Transport Response to Section 92 Request

PREPARED FOR BAYSWATER MARINA HOLDINGS LIMITED | MAY 2021

**BAYSWATER MARINA HOLDINGS LIMITED
BAYSWATER MARITIME PRECINCT TRANSPORTATION ASSESSMENT – TRANSPORT RESPONSE TO
S92 REQUEST**

Following submission of the resource consent application (BUN60373319 dated 15 April 2021) for the above development, Auckland Council have issued a request for further information under Section 92 of the Resource Management Act 1991 (**s92 request**). The following responses address Transport related matters within the s92 request. These queries are cited in italics for ease of reference and responded to below.

Figure 3: Weekend Peak Hour Traffic Volumes

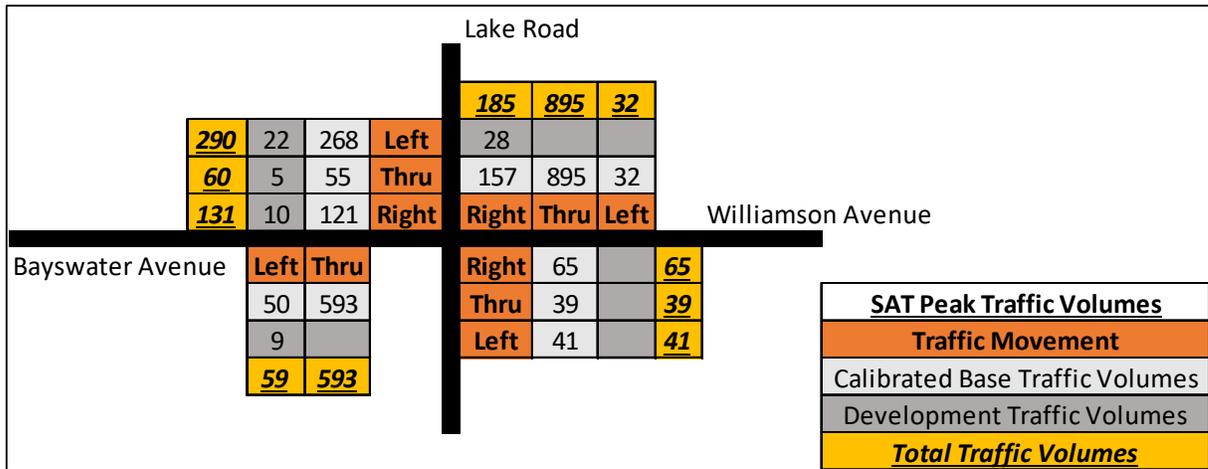
“The Lake Road / Bayswater Road intersection has been modelled with SIDRA using 2018 traffic volumes. The SIDRA model outputs show that the intersection is operating at an overall LOS of C in peak times. A LOS of C is considered to operate well with minimal delay or congestion. It is well understood that Lake Road can experience heavy congestion at peak times and this is confirmed by looking at the google maps traffic layer in peak times. It is acknowledged that the addition of the development traffic to the intersection is relatively low and will not have a significant effect on how the intersection operates. However, it is also important to understand how the intersection currently operates so we can assess the application accurately.

Please calibrate the Lake Road / Bayswater Road SIDRA base model with delay/ queue surveys to give confidence that the intersection is modelled accurately. It is also recommended that up-to-date traffic volumes are utilised and recommend that SCATS data (traffic volumes and signal phasing data) is obtained from Auckland Transport.”

The SIDRA model of the Lake Road / Bayswater Road intersection has been updated and calibrated based on the additional data obtain from the below listed sources:

The SIDRA model has been updated to reflect these volume changes as well as the phasing as per the SCATS data. The summary of the SIDRA results is in the following **Figure 4** to **Figure 9**.

Figure 10: Southern Precinct Rubbish Collection.

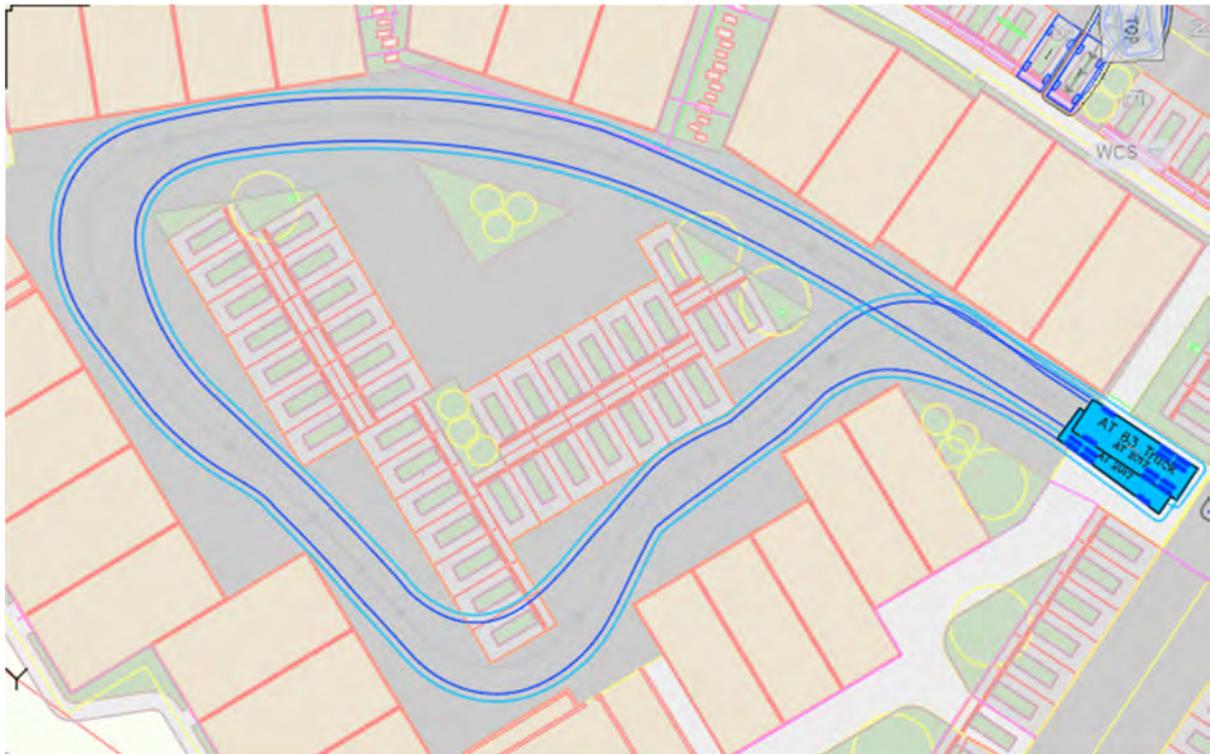
“It is not clear where the rubbish bins for the housing will be provided. Please show storage area for the bins in each of the precincts and the apartment buildings; and show on a plan where the rubbish truck will stop to collect the rubbish.”

“It is not clear from the plan or the transportation assessment what the arrangement will be for rubbish collection.

Please clarify /detail what the arrangements will be for the rubbish collection, including whether the collection will be private, the frequency of collection and whether there will be a central point for collection (rubbish /recycling) for the proposed residential dwellings.

Please provide plans that show the location of the bins and please provide tracking diagrams confirming that a 10.3m rubbish truck can safely enter /leave the site and track through the site (including the residential precincts).

The development’s rubbish collection will be managed privately and will be limited to a 8.3m rubbish truck. Each apartment/house rubbish bins will be collected separately from the internal parking areas provided for each precinct. The loading of rubbish will occur weekly for the residential apartments.

Sheet 2 of 7 within the Bayswater Maritime Precinct Transportation Assessment Report¹ shows the adequacy of the 8.3m rubbish truck within the central and northern precinct. Updated tracking curves showing the southern precinct are illustrated in **Figure 10** below.

The rubbish truck will be required to manoeuvre over two parking spaces. These parking spaces will have time restrictions applied to them as well as their wheel stops will be removed. This will ensure these spaces are clear during refuse collection.

Figure 11: Rubbish Truck Sight Line – Approximately 150m

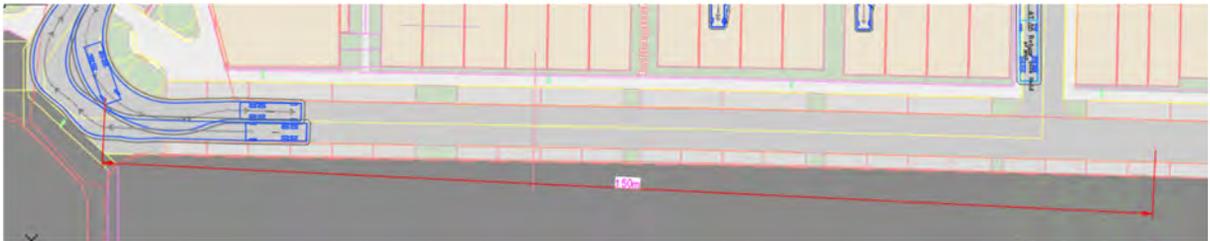
“Please provide a visibility assessment for vehicles travelling around the bend of Sir Peter Blake Parade and Cross Street. The vehicle tracking shows the rubbish truck has to cross the centreline on the bend. Please demonstrate on a plan that adequate sight lines are available to ensure oncoming traffic will have adequate space to stop to prevent either vehicle having to reverse within the roadway.”

Approximately 150m advance visibility is available for vehicles traveling south on Sir Peter Blake Parade towards point at which the rubbish truck crosses the centreline. The same applies for the rubbish truck from the point before it crosses the centreline. As such, adequate sight lines are available to ensure oncoming traffic will have adequate space to stop to prevent either vehicle having to reverse within the roadway. This is illustrated in **Figure 10** below.

Figure 14: Bus vs Car Manoeuvre on Sir Peter Blake Parade

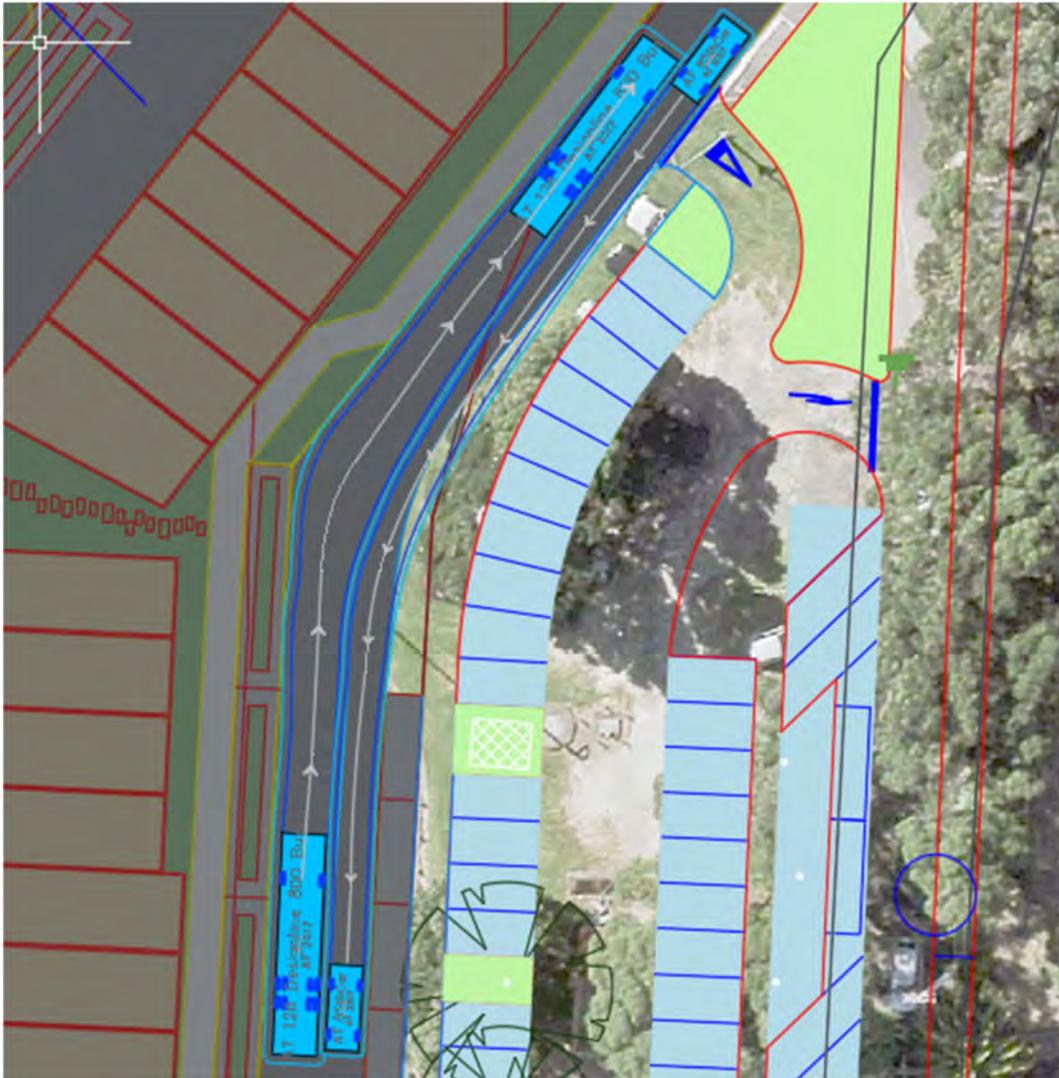
“The section 5.4 of the Assessment of Effects notes that bus access will continue to be available along Sir Peter Blake Parade and that it will finish at its current location and a turnaround area will be available however; there are no plans showing this location or turnaround. Please provide plans /amended information that shows the following:

- *Please provide updated plans showing a ‘marked out’ bus stop (including 15m long, 2.5m wide platform and bus stop road markings with same dimensions as the platform and shelter (detail to be confirmed at detailed design).*

To accommodate for a bus and car movement on the northern end of Sir Peter Blake Parade it will be required to widening the carriageway by about 1.5m. This will require the applicant as well as AT to provide for some additional land to accommodate these movement. This manoeuvre is shown in **Figure 14** below.
